City of Flagstaff

**CITY OF FLAGSTAFF
Engineering Division**

**RE: City of Flagstaff
Engineering Design and Construction Standards and Specifications
Administrative Revisions**

Figure 13-18-004-01

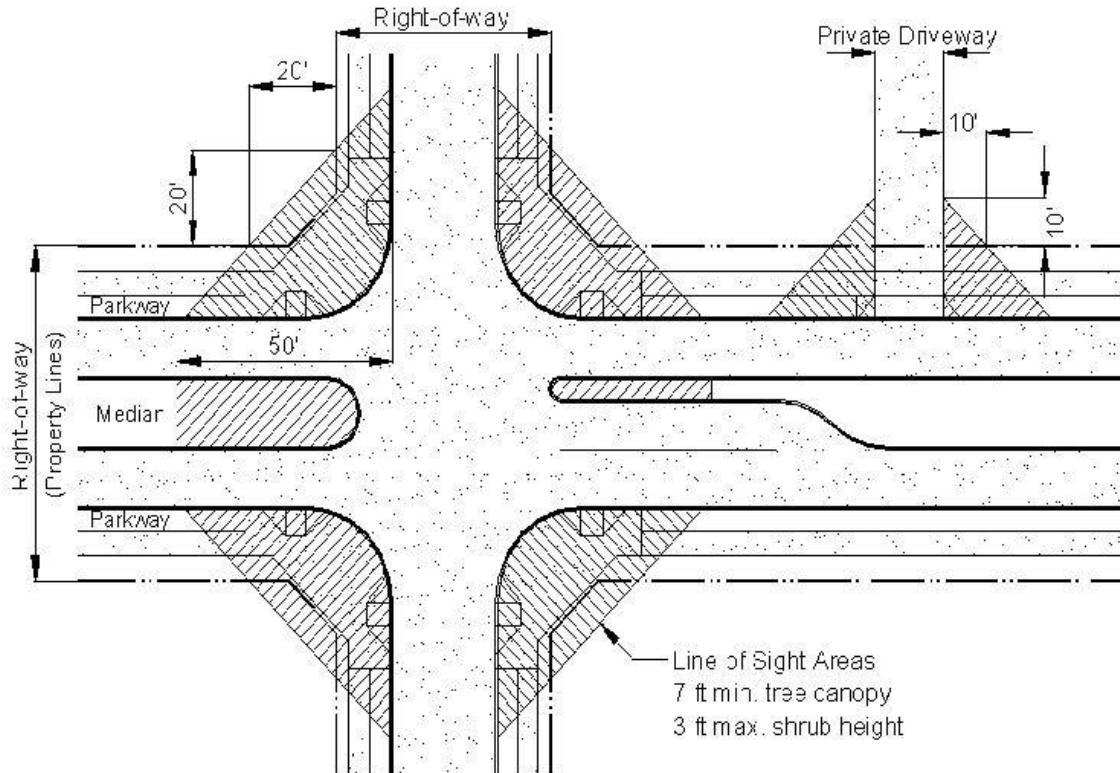
A. Lines of Sight. At intersections and driveways, landscaping proposed to be located within the line of sight-triangular area on a corner lot formed by measuring twenty (20) feet along both street side property lines from their intersection, or ten (10) feet from the intersection of a property line adjacent and parallel to a public street and a private street or driveway, shall be selected for and maintained at a maximum thirty-six (36) inch top height. Trees located within or overhanging these triangular areas shall have canopies selected for and maintained at seven (7) feet above street level. The end fifty (50) feet of mMedians, measured parallel to the directions of traffic, shall be treated in the same manner (see diagram below).

PW 50.10 Single and Double Trash Enclosure

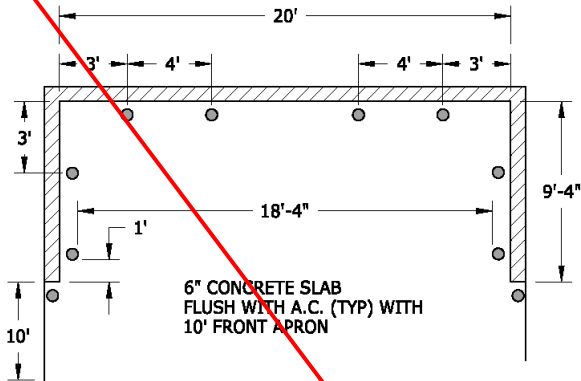
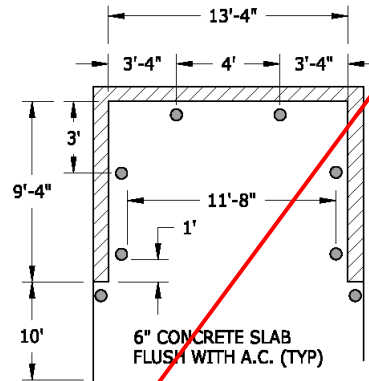
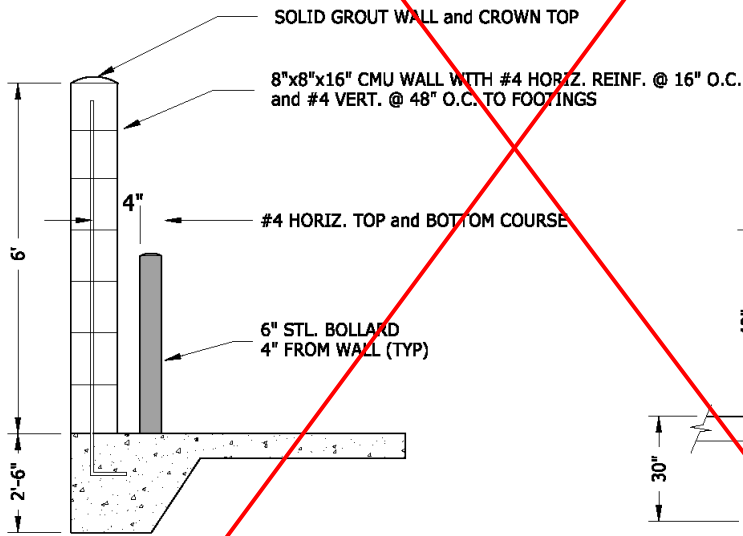
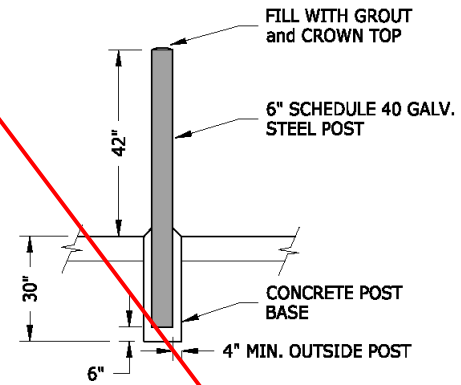
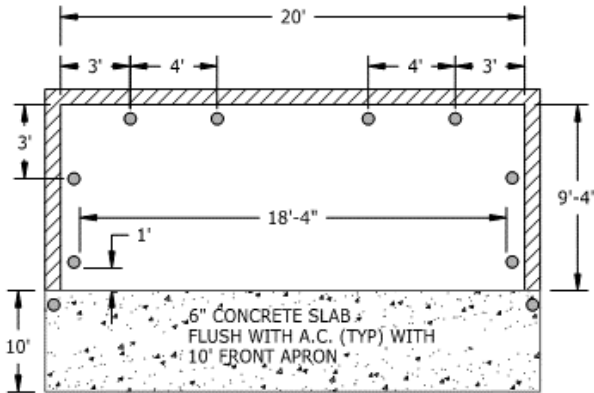
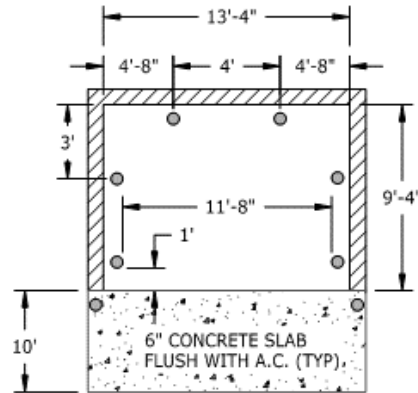
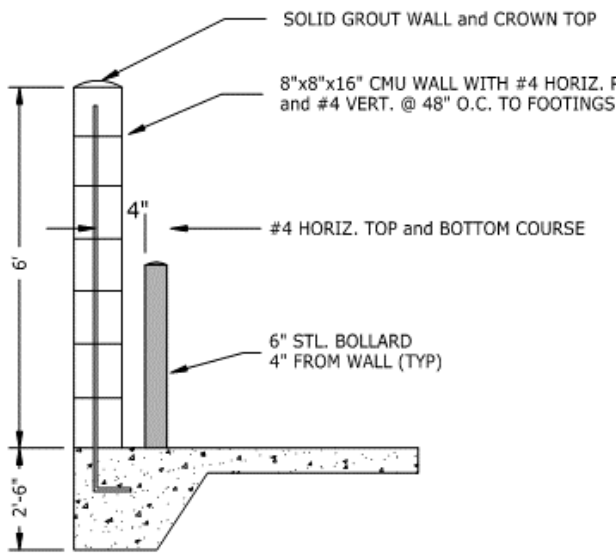
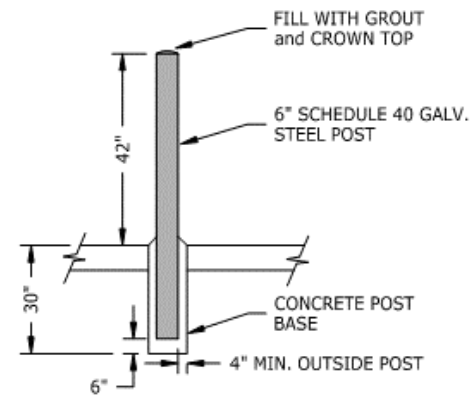
Replace Trash Enclosure Detail with corrected detail	11	13-23 Detail PW-50-10 1 of 2	Some of the dimensions were incorrect, and additional detail was added for clarification.
--	----	------------------------------	---
